**Product/Process Change Notice**

Application or type :  
Datasheet for CPDVR103V3U-HF.

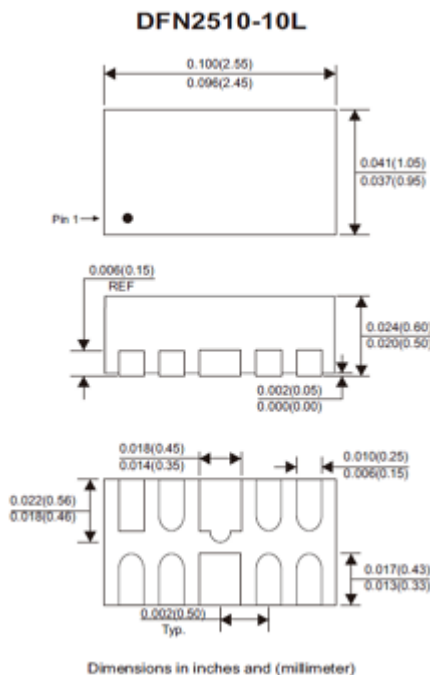
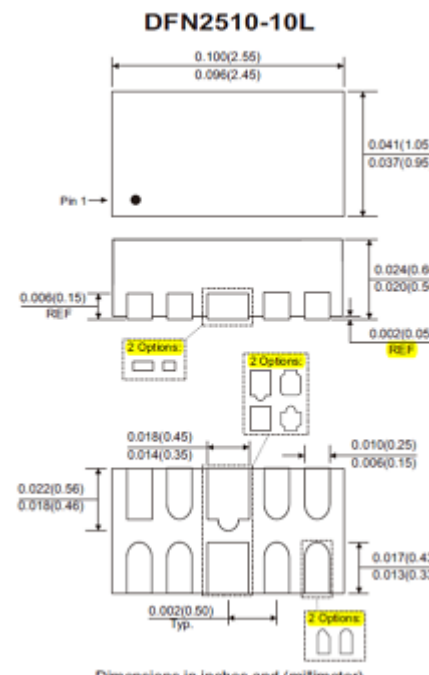
Detail of the change :  
Modify the dimensions diagram of the datasheet to conform to the product.

There are two types of pad appearance at the bottom of the actual product. Modify the dimension drawing of the data sheet.

There is no change to the product electrical specifications, the bottom pad appearance and dimensions is slightly different.
